RESOLUTION NO. R-4377

A RESOLUTION OF THE CITY COUNCIL OF THE CITY OF KIRKLAND ADOPTING A MASTER PLAN FOR WAVERLY PARK.

**Subject:** WAVERLY PARK MASTER PLAN, Analysis of compliance with Comprehensive Plan, Development Regulations, and Environmental Record

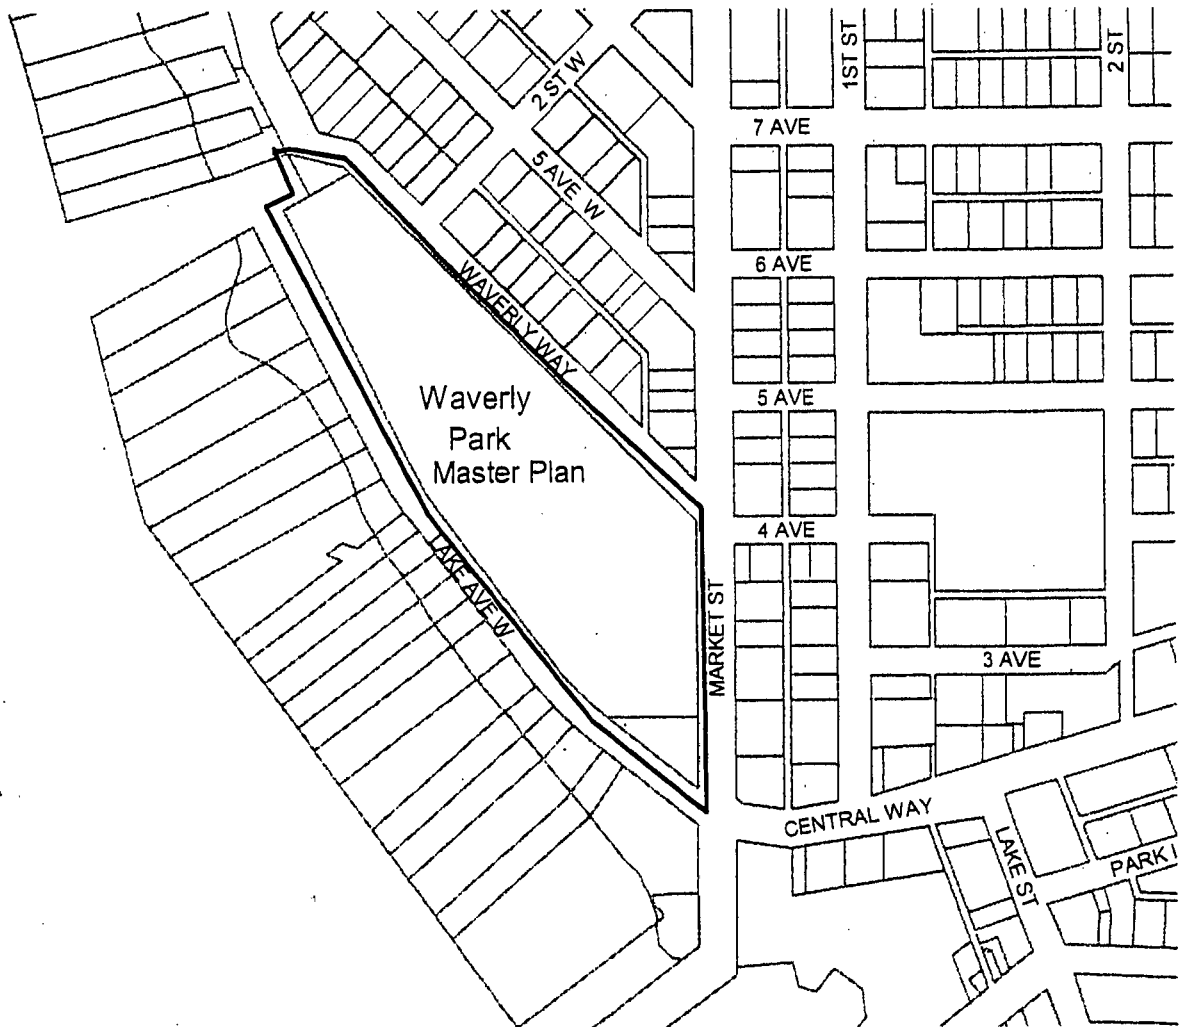
The proposal shows elimination of the existing bike lane along the west side of Waverly Way and replacement with a bike lane trail traveling through the park.

8. Conclusion: The pathway through the park will retain needed pedestrian and bicycle connections and meets the intent of the Comprehensive Plan.

# Waverly Park Schematic Plan

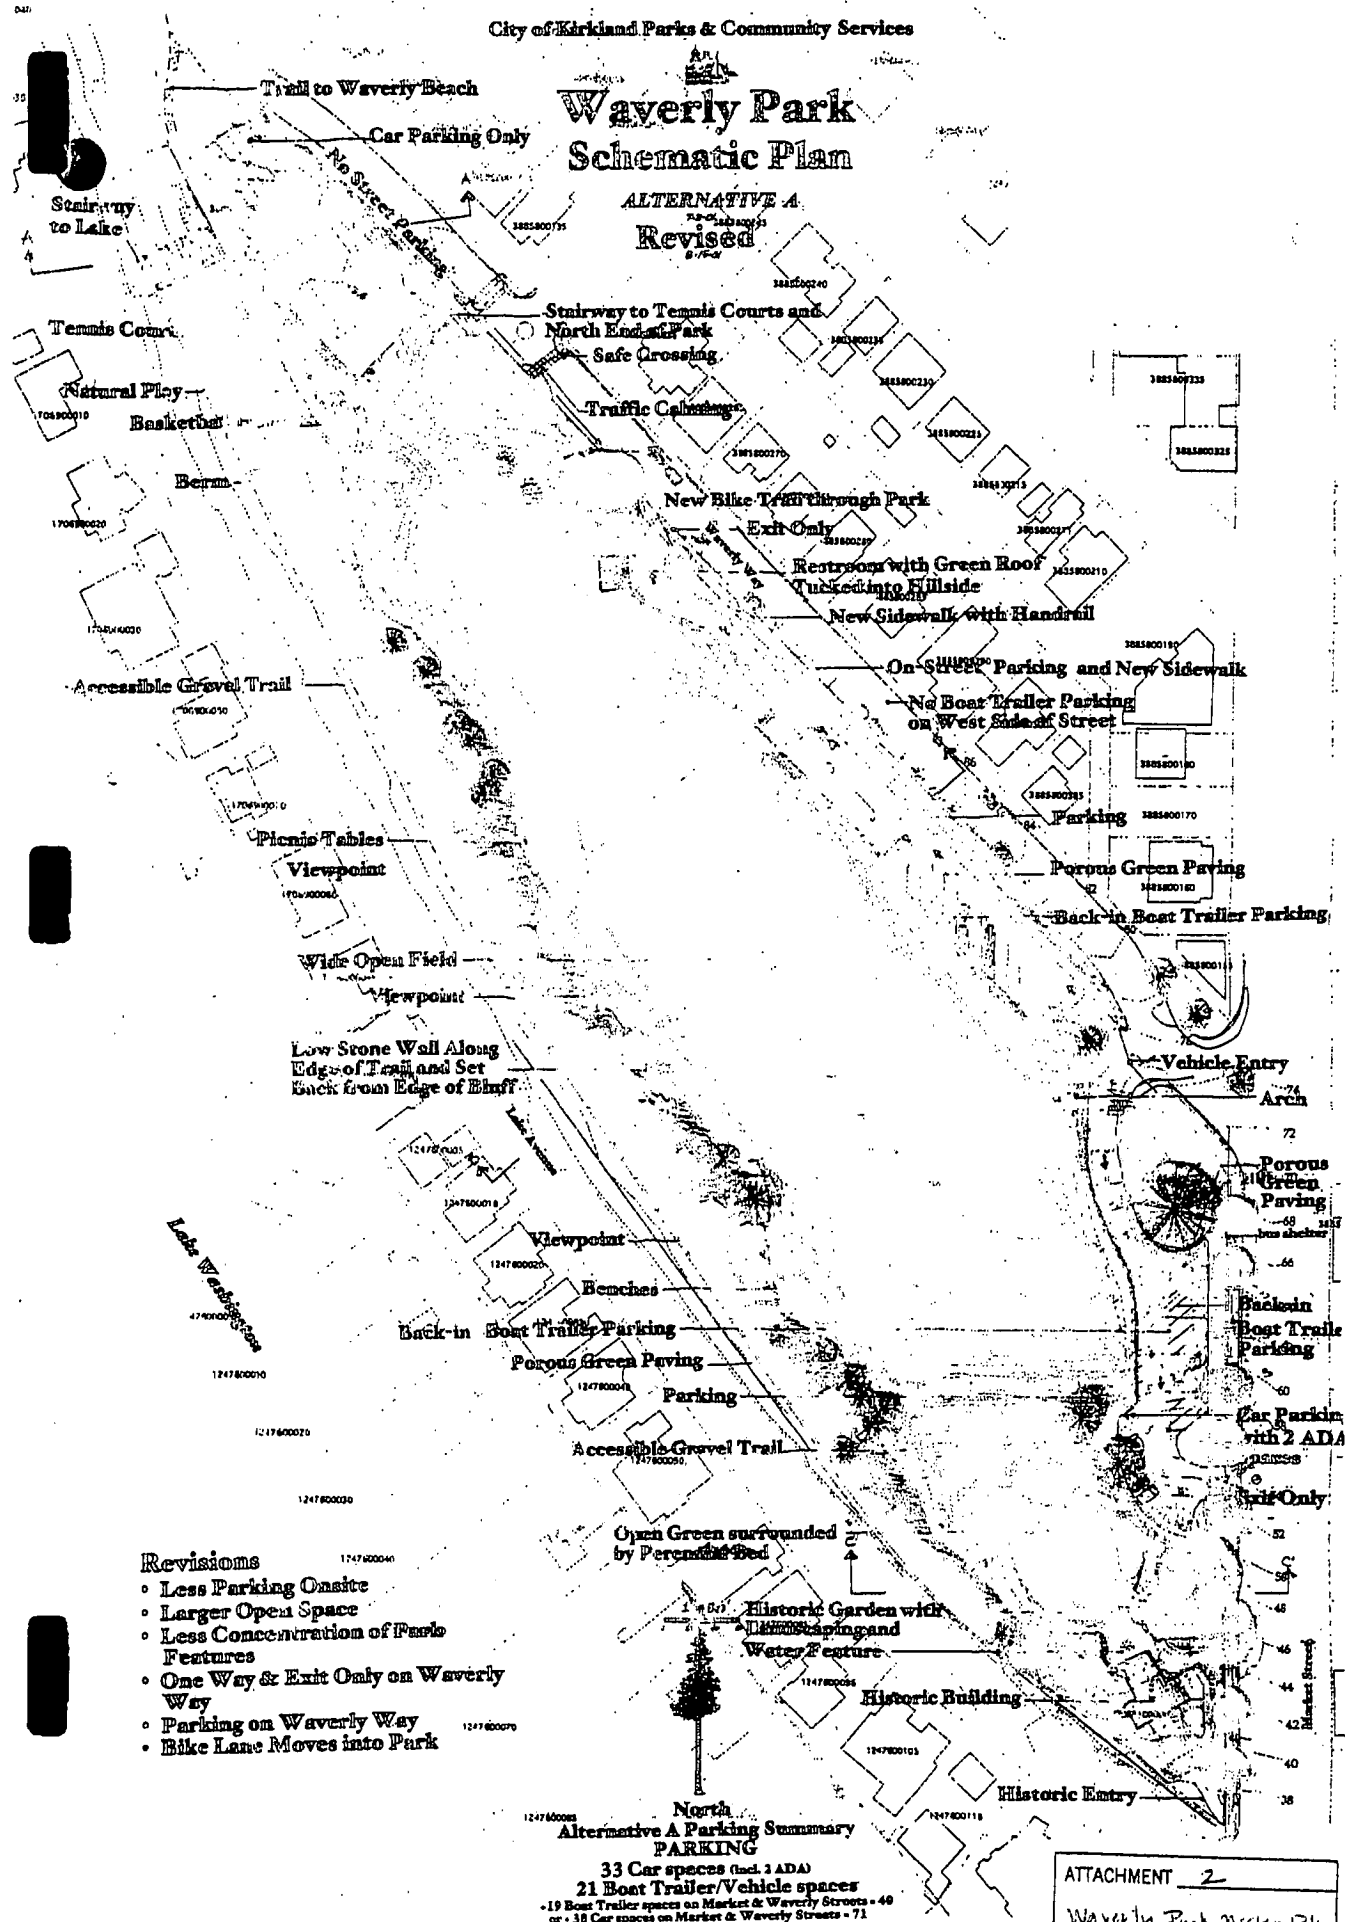
*Staff Analysis: Covered bicycle parking should be provided within 50 feet of the entrance to Heritage Hall. No bicycle parking facilities are currently shown on the site plan.*

In the proposed parking plan, there are some rows that contain more than eight contiguous spaces.

- a. Covered bicycle parking should be provided within 50 feet of the entrance to Heritage Hall.
- b. The design plans for the restroom facility shall include overhead weather protection along the portion of the restroom that adjoins the pedestrian walkway.

1. The proposed final parking design is consistent with the requirements for parking lots established in Chapter 105 with the following revisions:
  - a. The parking lot should be designed consistent with the standards outlined in Attachment 3.
  - b. The parking lot should be revised so that no more than 8 contiguous spaces are provided in each row of spaces, unless a modification to the parking lot landscaping is granted subject to compliance with the criteria set forth in KZC 105.103.e.

- c. The parking lot should be surfaced with asphalt or superior material. In order for the porous green paving to be used, it must be found consistent with the criteria set forth in KZC 105.103.h.
- d. The temporary use of the existing gravel parking lots is consistent with the modification criteria established in KZC 105.103.h and should be permitted until such time as funding sources for the development of the remaining portions of the public park become available, provided that appropriate periodic maintenance of the parking lots is completed (e.g. removal of potholes).
